## Initial PSC Questions and Staff Responses – Better Housing by Design Proposed Draft

August 31, 2018

## VISITABILITY PROTOTYPES STUDY

**OPT 4.5b** Building elevated 4.5 ft w/ front ramp

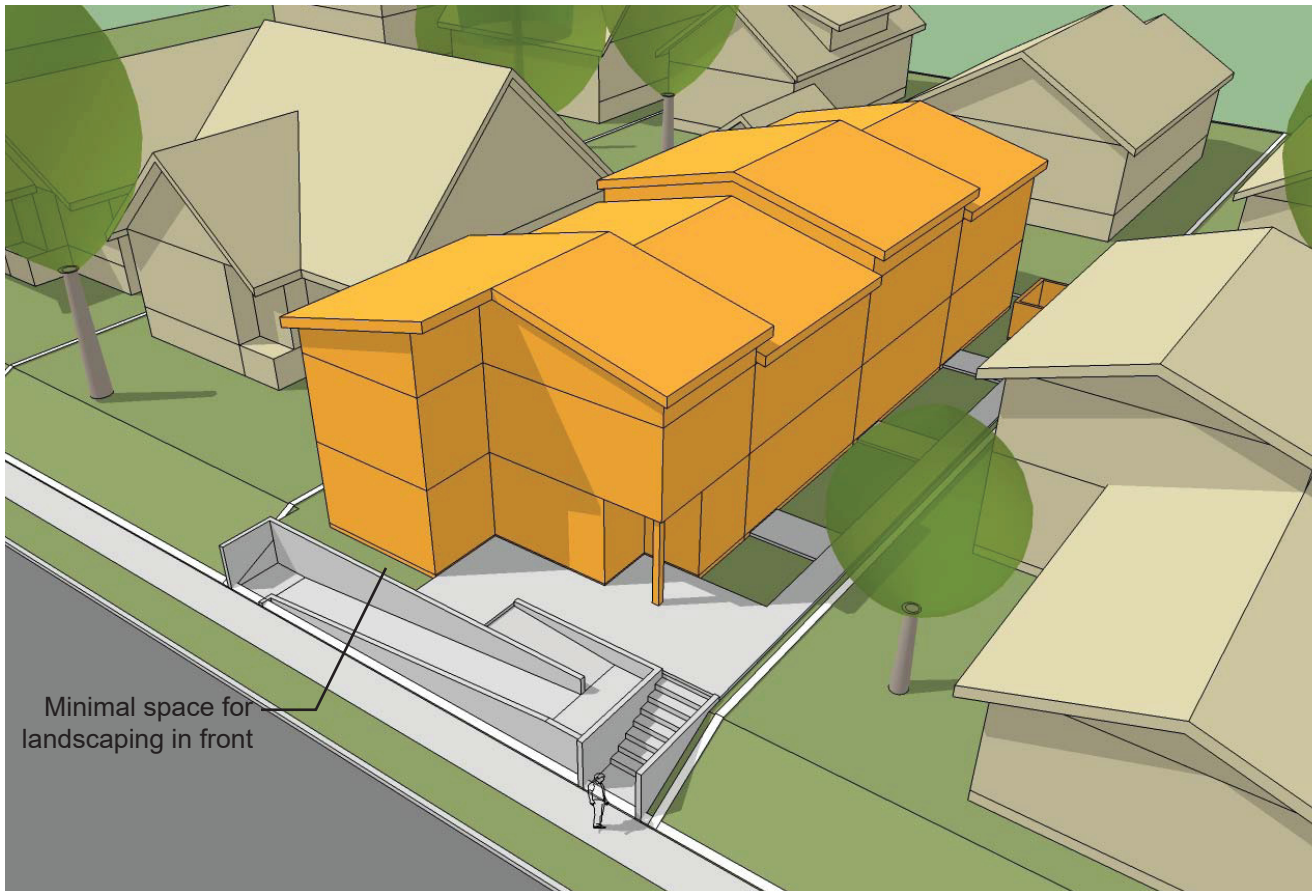
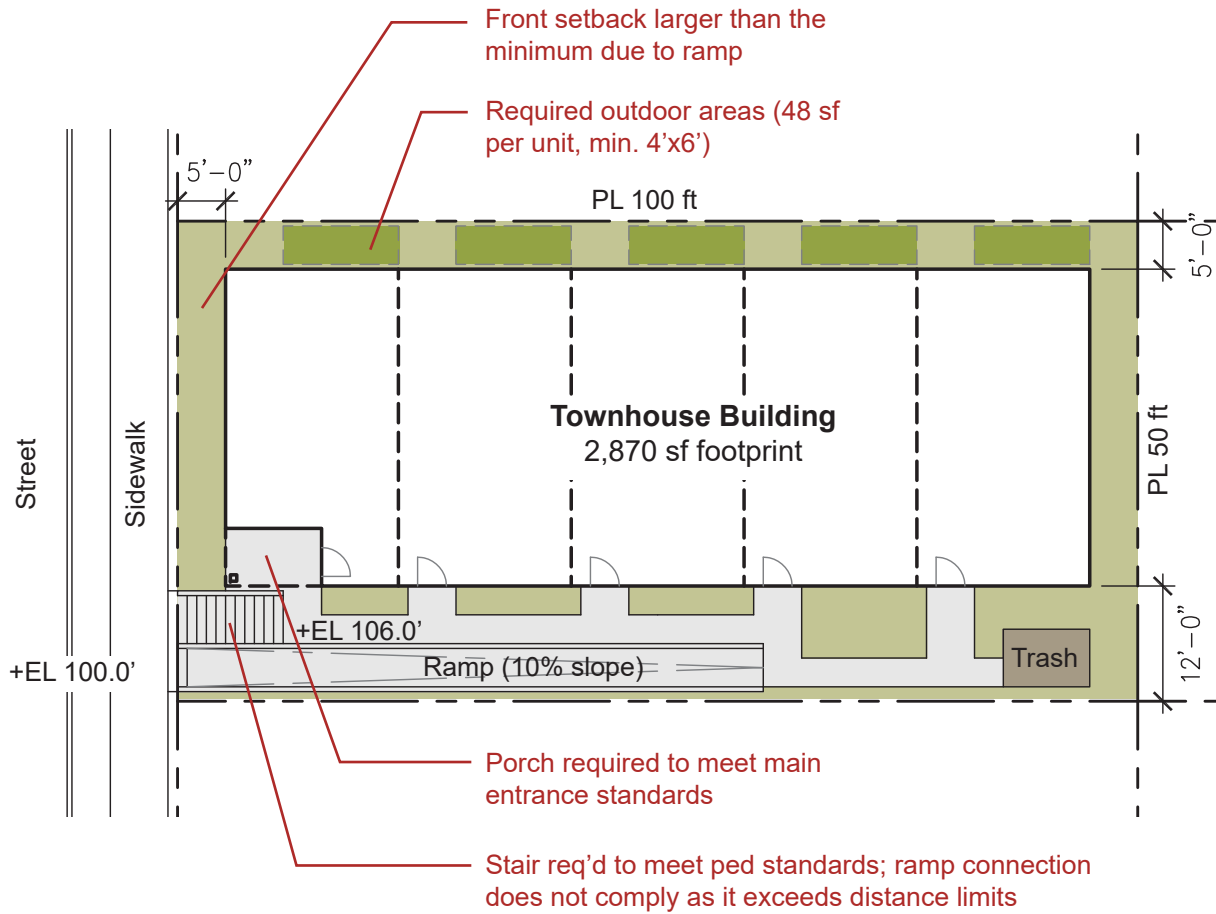
1) Going to 5 units in this configuration will require sub-16 foot widths for rowhouses, which may be less than ideal.

**OPT 6a** Building elevated 6 ft w/ side ramp

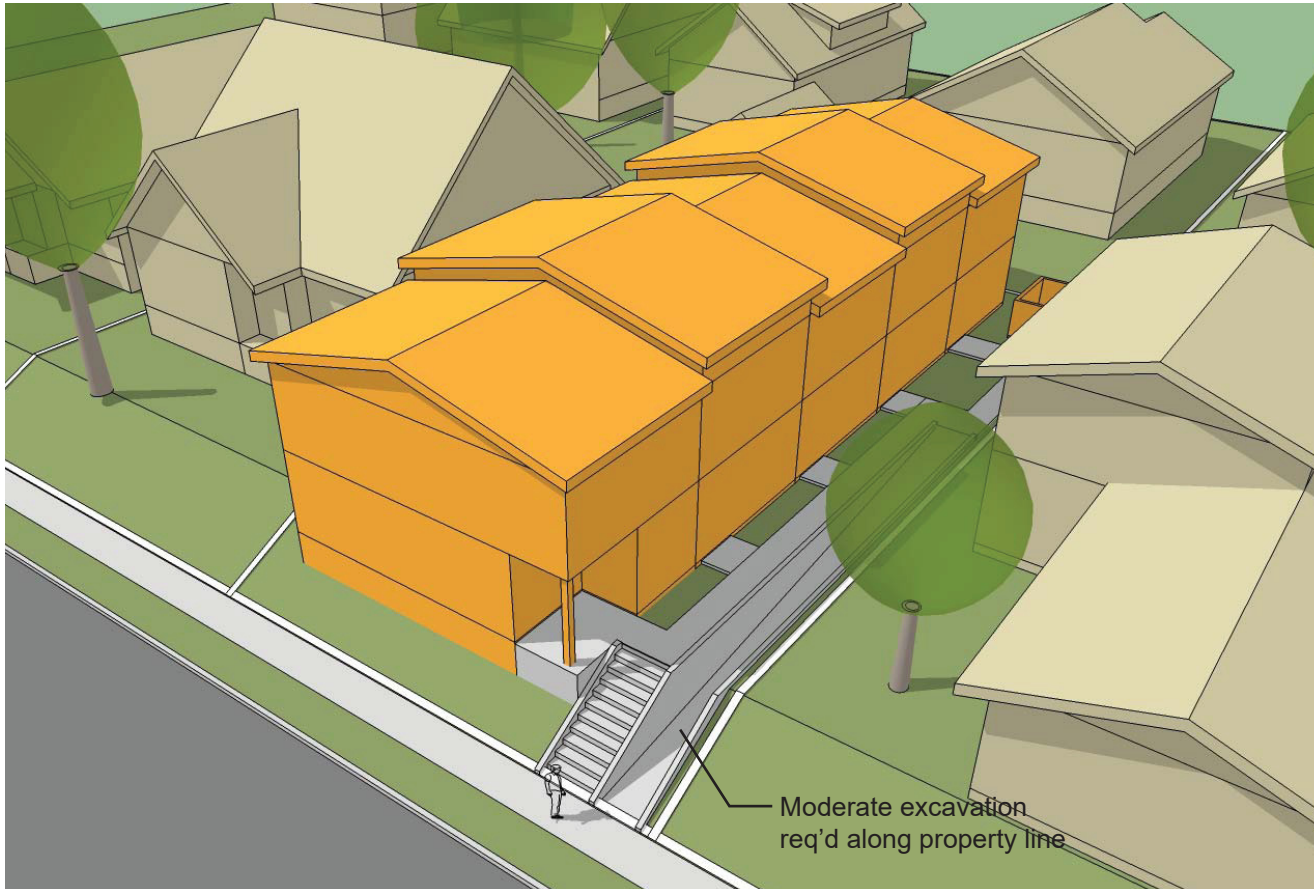
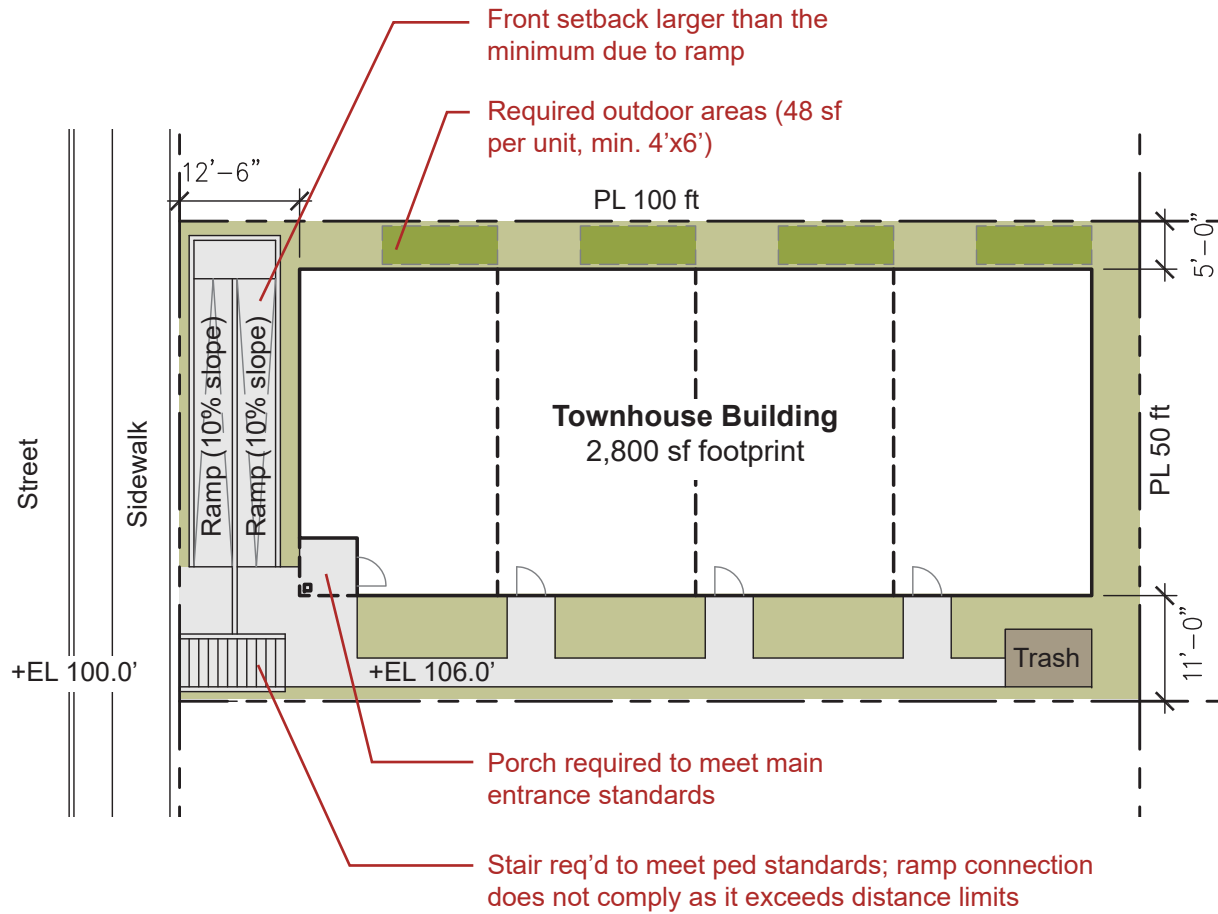
1) Traversing 6ft of grade at 10% requires a 60 ft long ramp. In this scenario, a single run of ramp may be difficult for many wheelchair users to navigate without an intermediate landing.
